# **LINCOLN CITY/LANCASTER COUNTY PLANNING STAFF REPORT**

**for June 11, 2003 PLANNING COMMISSION MEETING**

**P.A.S.:** Special Permit #2010

**PROPOSAL:** A community unit plan for 66 residential units. This application was originally considered by the Planning Commission at the May 14, 2003 hearing but was deferred to allow additional waivers to be included in the legal notice. The site plan has been revised as have the waivers being requested. Waivers to allow sidewalks on one side of the road, for tangent length on a curve, and slope at intersection approaches are no longer requested. However, waivers to yard setbacks and to the requirement for a community outdoor recreation plan are now included.

SITE PLAN	
PINE LAKE HEIGHTS SOUTH 8TH ADDITION C.U.P.	2003
LINCOLN, NE

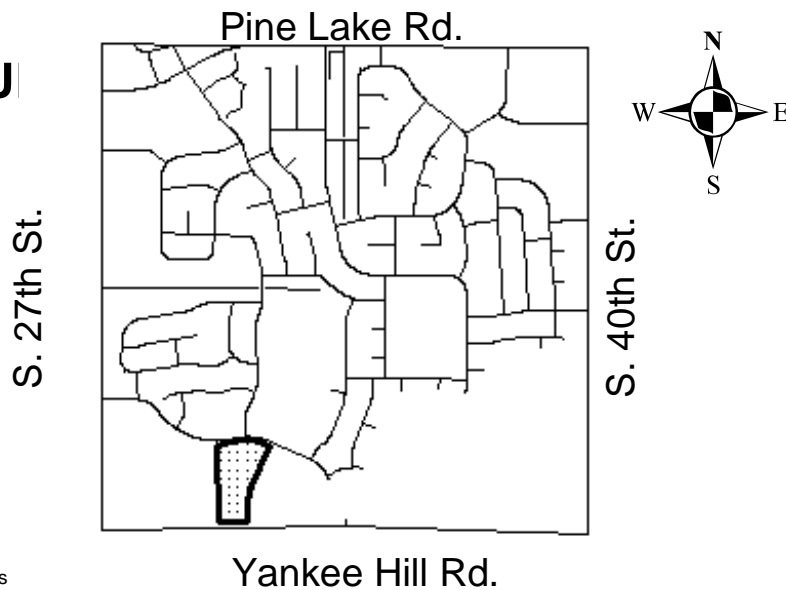
1. Apart from those to the platting process, the waivers requested are a result of the density caused by the number of structures shown on the site plan for the CUP. It appears that a reduction in the number of units alone would enhance the project and eliminate the need for at least two of the requested waivers.
2. A waiver to allow sidewalks adjacent to the roadway is requested in the letter from Olsson Associates. However, there is no design standard that specifies a minimum separation between the back of curb and the sidewalk in a CUP. However, a 4' separation is required in the mobile home court design standards. This provides for a separation between pedestrian and vehicular traffic and enhances pedestrian safety, and helps ensure that sidewalks remain clear when snow is plowed from the streets.

The sidewalks are adjacent to the roadway in an attempt to provide adequate room to park a car in the driveway. Public Works recommends 22' of clear space between sidewalk and garage for vehicle parking so cars don't overhang onto the sidewalk. As shown, several lots do not provide 22' of clear space for vehicle parking and creates an unacceptable situation where vehicles will be parking over the sidewalk and impeding pedestrian circulation. Additionally, parking on the private roadways is substantially limited due to the narrow lots and the number of driveways. With standard lot widths of 30', there is limited space for on-street parking for guests. Safety should not be reduced to increase density.

Grainger Parkway is intended to be a main pedestrian and vehicular transportation corridor through this area. A sidewalk connection from San Augustin Drive to Grainger Parkway between either Lots 9 and 10 or between Lots 12 and 13 should be provided.

3. A waiver to the minimum lot area of 2,500 square feet is requested. This waiver may be acceptable based upon a revised layout that decreases the overall density but that continues to use adjacent outlots to maintain separation from the street and the boundary of the CUP. However, while correctly identified as a side yard, the proposed setback for Lots 15-35 along the east boundary is inadequate as shown. In reality, this is the rear yard for those lots, and the minimum rear setback for the R-4 district should be provided. This setback may be measured between the building and the east boundary of the CUP.

Additionally, the separation between Lot 49 and the adjacent lots to the east, between Lots 55 and 56, and between Lots 58 and 61 is quite small. This is significant because a waiver to setbacks has been requested to allow the structures to be built to the lot line. Again, a decrease in the overall density would provide an adequate separation in those cases where buildings back up to others. The minimum rear yard setback for the R-4 district should be provided between Lots 45 - 58, and the adjacent lots.

4. A waiver to cul-de-sac geometry is requested because providing the required 43' standard radius will result in the loss of units. In the previous staff report, Public Works noted that the 21' radius shown on the plans was not acceptable, and that a 30' radius was the minimum acceptable radius. The plan has been revised and now shows a 30' radius.

6. The grading and drainage plan must accommodate the 100-year storm event. This plan must be revised and approved by Public Works.
7. A waiver to the requirement that a community outdoor recreation plan be included as part of the CUP is requested. In the previous report, it was noted that a recreation plan

must be developed and submitted for the Parks and Recreation Department to review, and at a minimum it must include a half-court basketball court, a seating area, and a tot lot for children between the ages of 2-5. These recreation plans provide open space and recreation facilities that serve as an amenity for all residents and help offset the increased density, and one should be required as part of this project. Additionally, there are other comments included in the review from Parks and Recreation that must be corrected to comply with the Zoning Ordinance and Design Standards.

8. Given the location, Tularosa Lane must include the prefix 'South'.
9. The use of outlots must be designated, and in this case they are for private roadways and open space. The identification of Outlots B - E should be modified to indicate their use as open space, with blanket utility easements.

- Although there are no adopted design standards that address driveway length in relation to the sidewalk and curb line, 22' has traditionally been the minimum distance required from the edge of the sidewalk to the garage. This distance provides 2' of clearance in front of and to the rear of the standard 18' vehicle and helps prevent vehicles from blocking the sidewalk or overhanging across the curb line. The proposed plan shows many lots with less than 22' and some with as little as 14' from the garage line to the edge of the sidewalk.

- Also, there are no adopted design standards for sidewalk location in relation to the curb line. However, Public Works agrees that building sidewalk that abuts the curb line, as proposed in this project, would cause safety issues with pedestrian traffic right next to the roadway. Also, snow removal would undoubtedly continually cover and block the sidewalk.

- 1.1 Revise the site plan to:
  - 1.1.1 Include in the waiver notes the waiver of the preliminary plat and allow the Planning Director to approve administrative final plats and the approval of administrative final plats accepting the dedication of streets in the Requested Waivers table on the site plan.
  - 1.1.2 Show a sidewalk connection from San Augustin Drive to Grainger Parkway between either Lots 9 and 10 or between Lots 12 and 13.
  - 1.1.3 A rear yard setback between Lots 15 - 35 and the east boundary line of the CUP consistent with the R-4 district.
  - 1.1.4 Provide the rear setback required for the R-4 district between Lots 46 - 58 and the adjacent lots to their rear.
  - 1.1.5 A signed surveyor's certificate.

- 1.1.6 Show Tularosa Lane as South Tularosa Lane and provide a suffix for the permanent dead-end roadway south from Gallinas Drive.
    - 1.1.7 Increase the setback along Yankee Hill Road to 35' to respect the LES easement.

- 1.1.8 Indicate the purpose of Outlots B - E as open space, with a note providing a blanket utility easement.
    - 1.1.9 A 4' separation between the sidewalk and the back of curb.

- 1.1.10 A parking space 22' deep on the driveway between the sidewalk and the garage.
  - 1.2 Revise the landscape plan to:
    - 1.2.1 Correct Notes 3-5 to include proper street names and delete references to landscaping in cul-de-sac and eyebrows.

- 1.2.2 Provide screening per Design Standards.
  - 1.3 Submit a recreation plan approved by the Parks and Recreation Department.
  - 1.4 Add the notes requested by LES in their April 25, 2003 review.
